Planning Commission Meeting

March 14, 2023 6:00 PM

4.I. 0 Norman Berry Drive Rezoning Request

4.III. 3034, 3038, and 3044 Springdale Road Site Plan

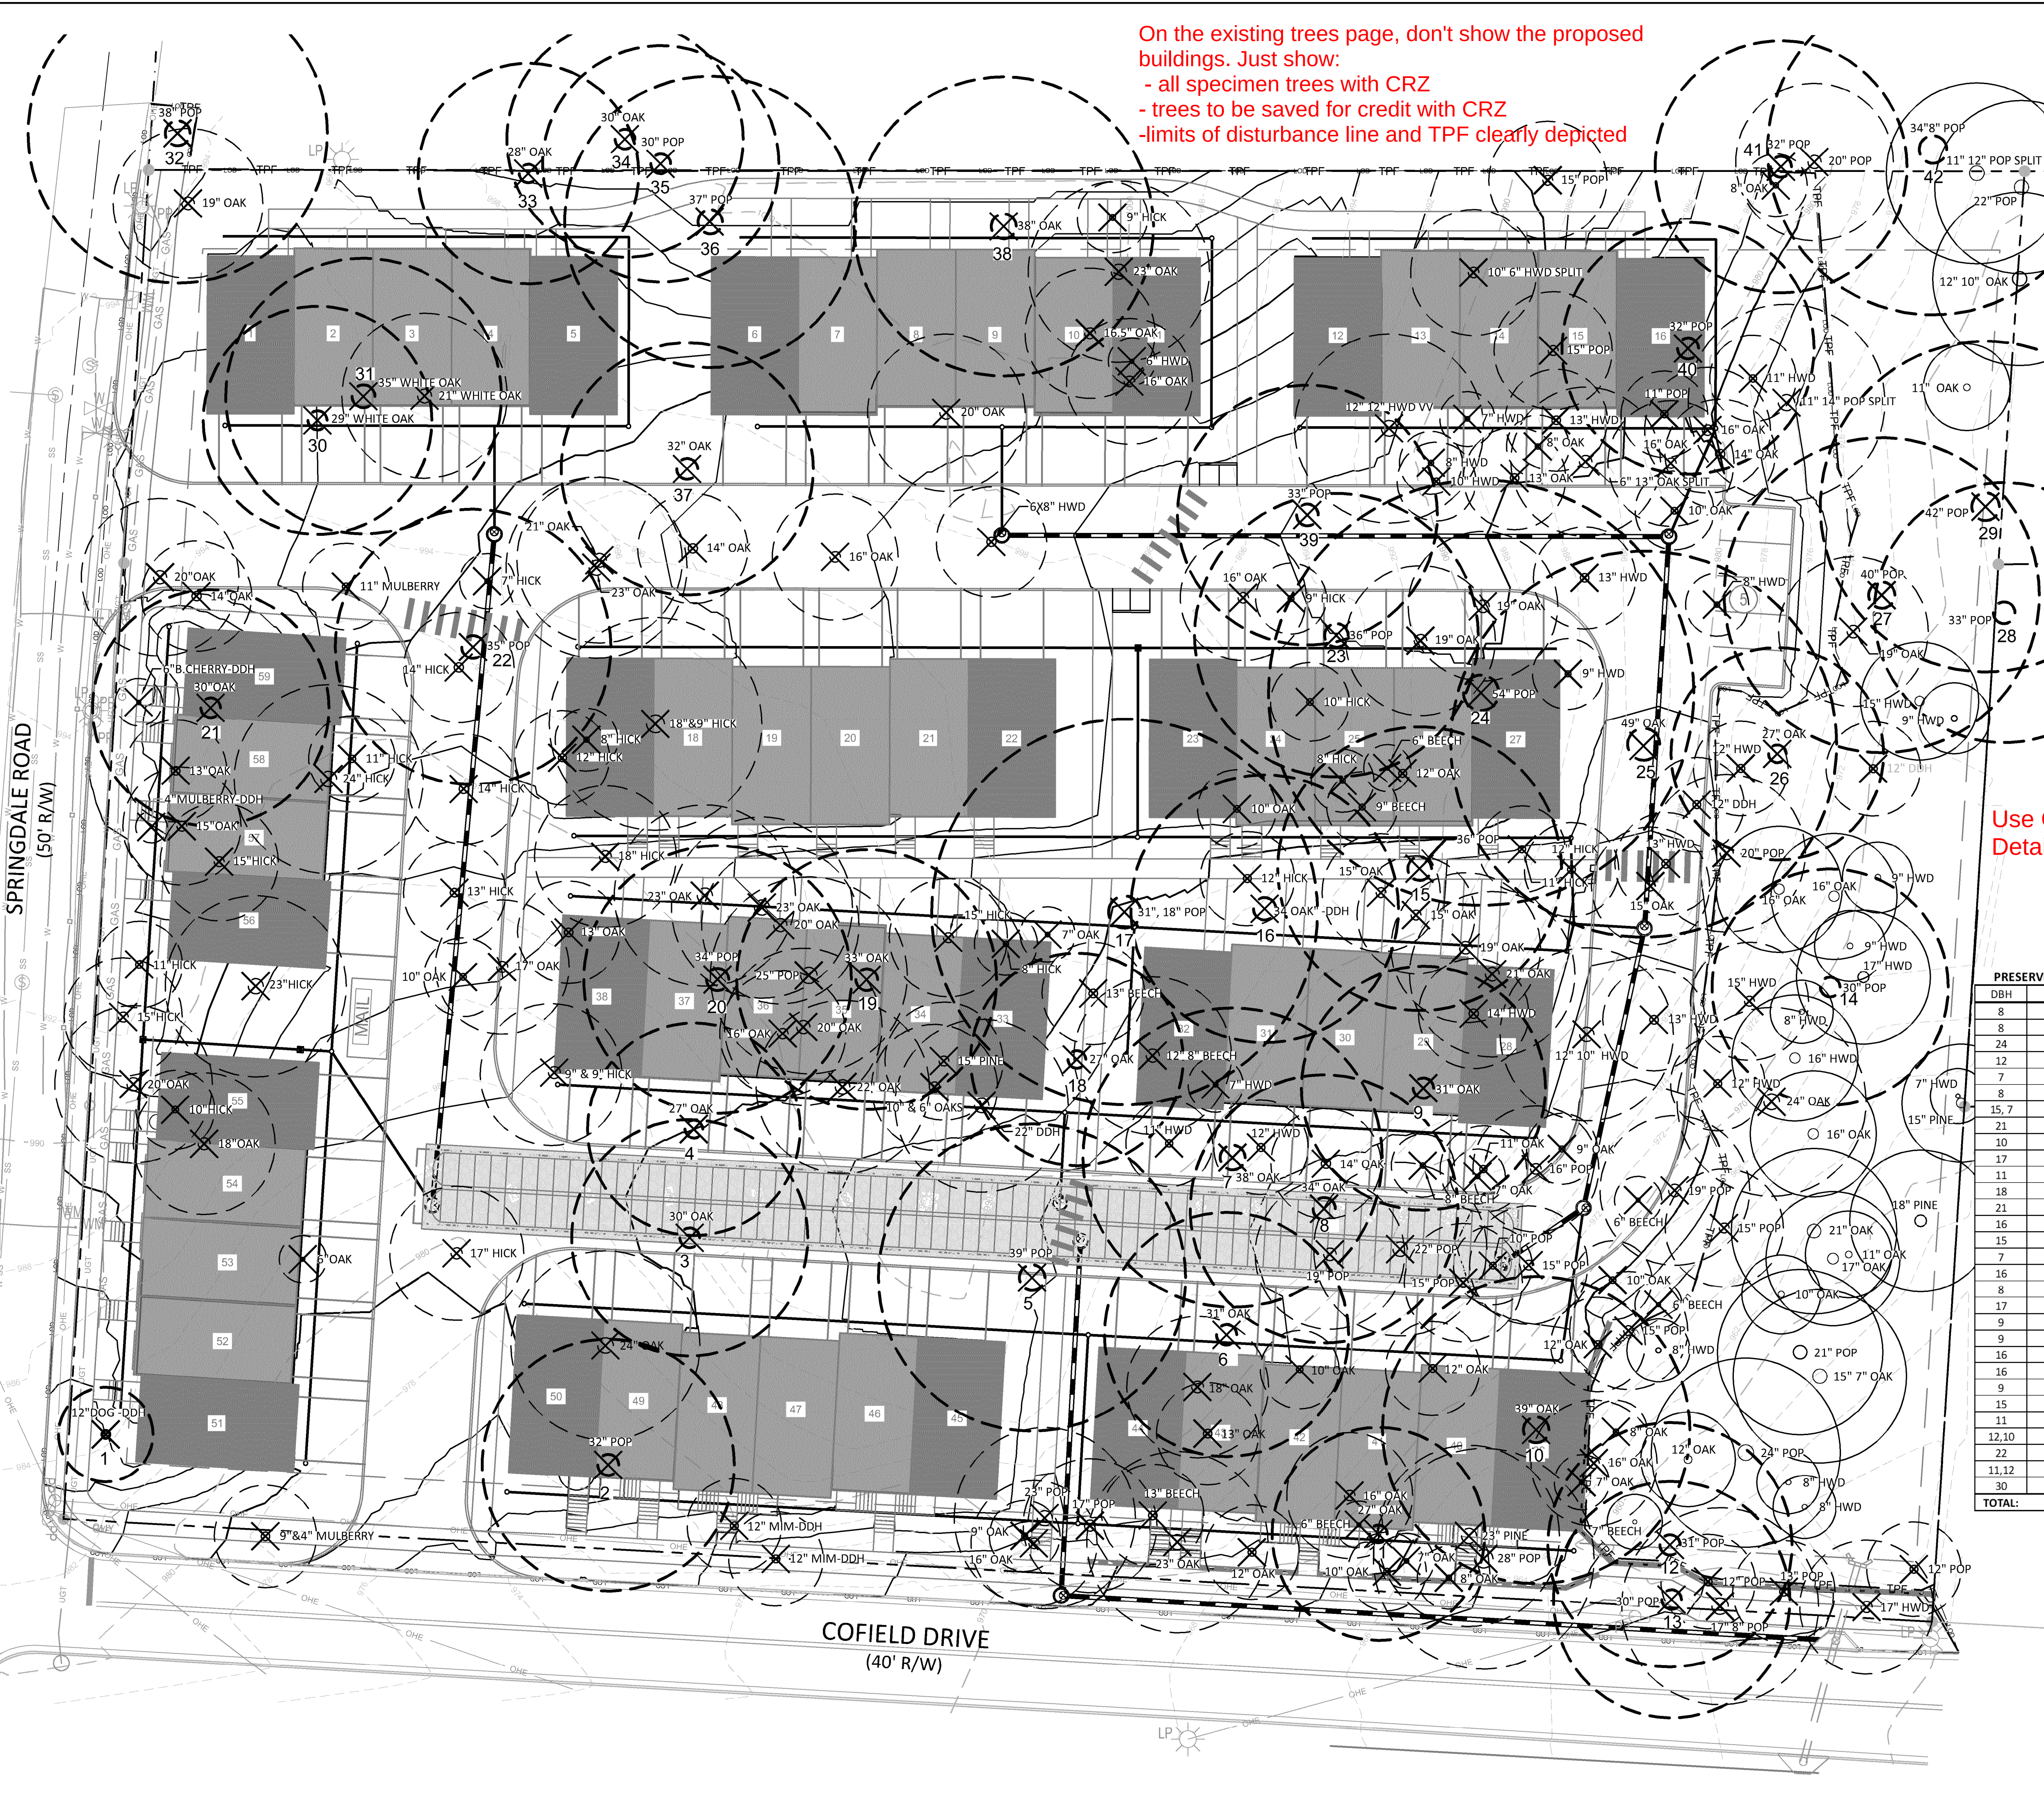
On the existing trees page, don't show the proposed buildings. Just show:
- all specimen trees with CRZ
- trees to be saved for credit with CRZ
- limits of disturbance line and TPF clearly depicted
